Determination 2012/052

Regarding a code compliance certificate issued in respect of a pool barrier at 32 Tullamore, Maunu, Whangarei

Figure 1: Junction of the masonry fence and the pool gate

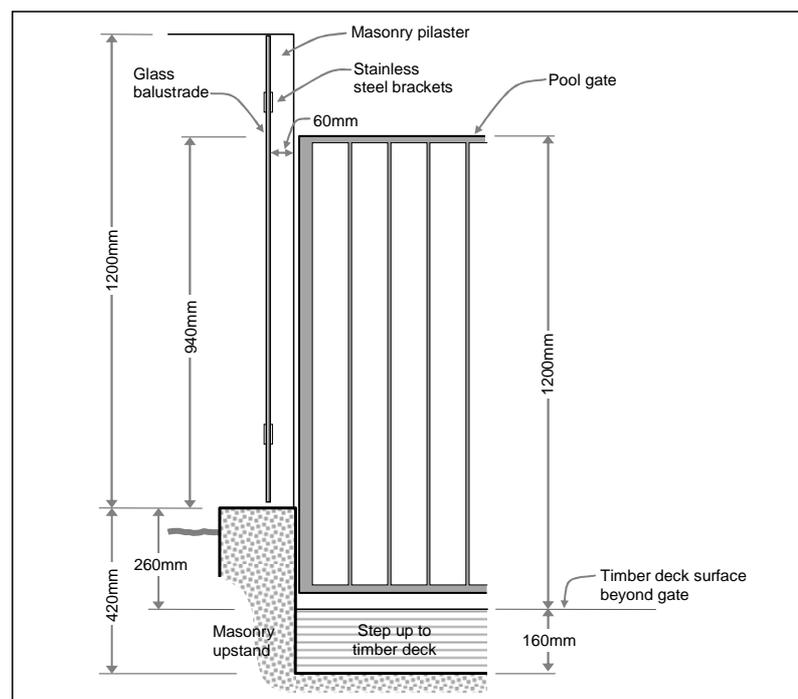
- 2.4 The height of the upstand varies as the ground slopes down from west to east, and is 420mm at the east end where it meets the southeast pool gate. The pool gate is 1.2m high and is fixed to the top of the deck. The distance from the toehold on top of the masonry upstand to the top of the southeast pool gate is 940mm. The junction of the masonry fence and the pool gate is shown in Figure 1 above.

[The authority's] position ... is that the ... masonry [upstand], being constructed immediately adjacent to the pool gate, constitutes a permanent projection or object, outside of and within 1.2m of the pool fence, effectively reducing the height of the pool gate to a non compliant 940mm, and was therefore a clear breach of clause 1.1(b) of the

... due to the construction of the [masonry upstand] built immediately adjacent to and at a right angle to the pool gate, effectively reducing the height of a pool gate at that location, then the 'fence' is not constructed and erected so as to inhibit any child under the age of 6 years from climbing over the fence from the outside.

5.3.7 As shown in Figure 1, the pool gate is 1200mm high has a rail at top and bottom. The horizontal rail provided by the masonry upstand is immediately adjacent the pool gate. However, the vertical distance between the masonry upstand and the top of the adjacent pool gate is 940mm, and is greater than the 900mm minimum dimension provided for in paragraph 5A. On this basis I consider the masonry upstand complies with the requirements of paragraph 5A.

- 6.1 In accordance with section 188 of the Act, I determine that, in respect of the southeast pool gate and adjacent masonry wall, the pool barrier complies with Clause F4 Safety from Falling of the Building Code, and accordingly I confirm the authority's decision to issue the code compliance certificate.
